Southeast
Missouri State University

June 2, 2010

This letter is to clarify the issues you raised with respect to our amendment request to nuclear materials license No. 24-09296-02. Those issues are as follows:

Magill Hall Basement Level

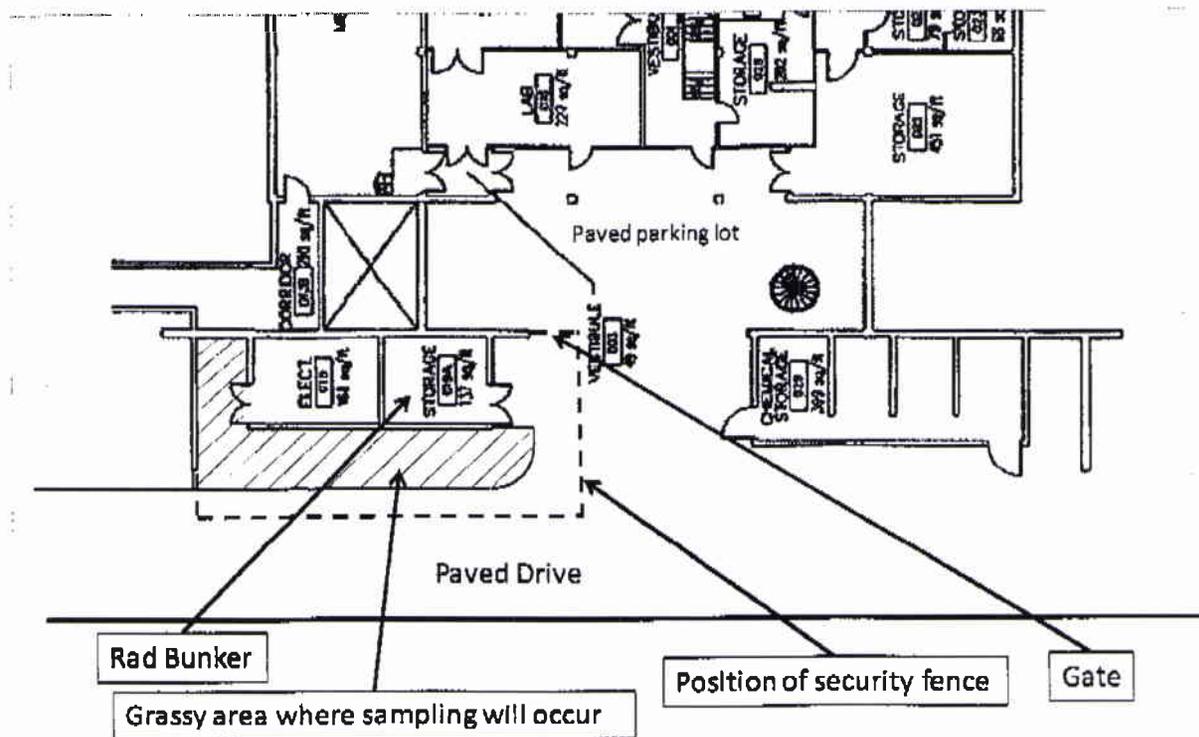
Confirm the area that will be restricted. It appears that the area of interest in your diagram is the shaded area. If so, confirm that the shaded area will be completely enclosed. Also specify the dimensions of the area.

I have included a new diagram with this letter. The shaded area in the diagram is the grassy area. The dashed line represents the outline of the fenced in area. The fence adjoins a retaining wall on the west side which is 8 feet high. This retaining wall is connected to Magill Hall proper, and the walls there are 8 to 10 feet in height. This assures that no pedestrian entrance is possible without considerable effort and premeditation. The grassy area is approximately 8 feet wide by 42 feet long. The inset on the west side is about 10 by 10 feet. The entire enclosed area is about 20 feet by 44 feet.
